MCF5235 Chip Errata

Silicon Revision: All

This document identifies implementation differences between the MCF523x processors and the description contained in the *MCF5235 ColdFire® Reference Manual*. Refer to <http://www.freescale.com/coldfire> for the latest updates.

Figure 1. Buffer Overrun Example

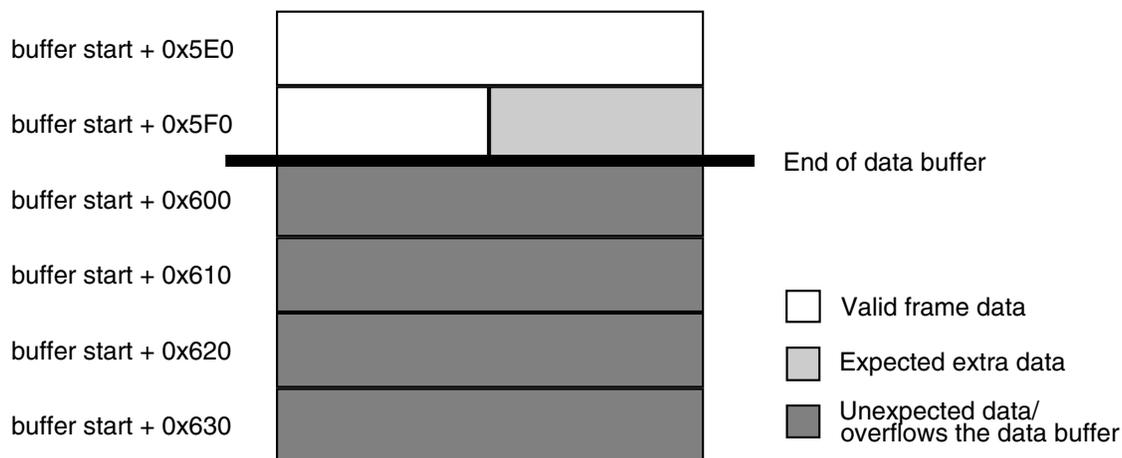
Description: When the FEC is connected to a 10BaseT network, if length of the data stored in a descriptor is not evenly divisible by 16 (not line-aligned), the FEC writes extra lines at the end of the buffer. The entire line that contains the last valid data is written and at least one extra line, but up to four lines after the end of the valid data can also be written. In most cases, this is not a problem because the extra lines of data continue falling within the limits of the buffer. However, if the valid data ends near the end of the buffer, the extra lines written by the FEC might be outside of the data buffer. This leads to corruption of the next buffer, descriptor, data, or code stored in the adjacent memory.

For example, as shown in the figure below, if the max buffer size is programmed to 0x600 and a frame that is 0x5F8 bytes long is received, a line is written starting at buffer start + 0x5F0. The first half of the line at buffer start + 0x5F0 is valid frame data that should be processed by the FEC driver; the second half of the line is additional data that is written because the FEC only writes complete lines. This data should be ignored by the FEC driver. So far, this is correct FEC behavior as originally specified. However, the FEC repeats the last line of valid data a number of times. The line at buffer start + 0x600 is written, and as many as three additional lines beyond the end of the data buffer could be written.

Workaround: Only use 100BaseT.

Workaround: Allocate extra lines for the receive data buffers. The actual allocated memory for each buffer should be equal to the receive buffer size programmed in the FEC's EMRBR register plus four lines (16 byte-sized lines).

Workaround: Program the data buffer size one line larger than the max packet size (data buffer size = EMRBR + 0x40).
